**Implementation of Quality Assurance Criteria and  
10 CFR 50.59 for Nuclear Power Plant Components Produced  
Using Advanced Manufacturing Technologies**

**AMT Regulatory Basis Document  
AMT Action Plan, Revision 1, Subtask 2A**

**Implementation of Quality Assurance Criteria and 10 CFR 50.59  
for Nuclear Power Plant Components  
Produced Using Advanced Manufacturing Technologies  
(AMT Regulatory Basis Document)  
AMT Action Plan, Revision 1, Subtask 2A**

Figure 2 – Flowchart illustrating a hypothetical 10 CFR 50.59 screening of a change to use an AMT component

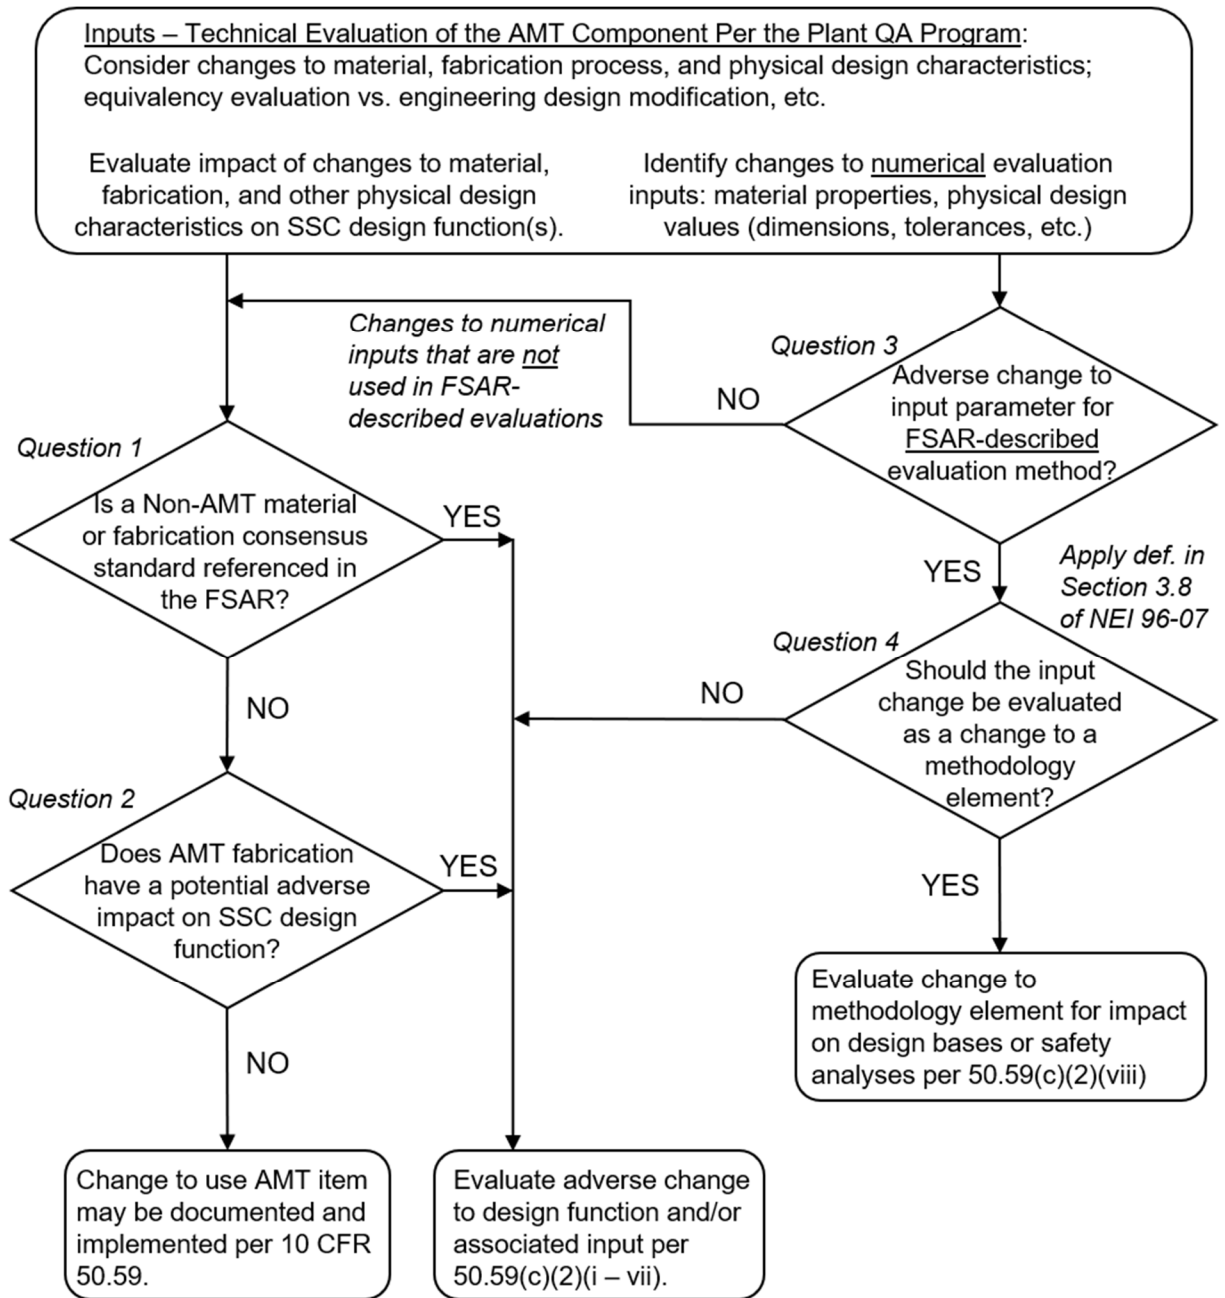
4	Page 33, Figure 2	NEI stated that the process conclusion on the bottom left of the figure would be more accurate if it stated that the change “...may be <b>documented and</b> implemented per 10 CFR 50.59,” rather than the change “...may be implemented per 10 CFR 50.59.” NEI explained that the end state for the other two processes shown in this figure would include documentation of the 10 CFR 50.59 evaluation and either implementation in accordance with 10 CFR 50.59 or the need for a license amendment request.	N/A	The staff accepts NEI’s proposed revision since a change that is implemented under 50.59 would be documented, consistent with the guidance in NEI 96-07. Therefore, the process conclusion on the bottom left of the figure on Page 33 is revised to state that the change “may be documented and implemented per 10 CFR 50.59,” rather than just stating that the change “may be implemented per 10 CFR 50.59.”
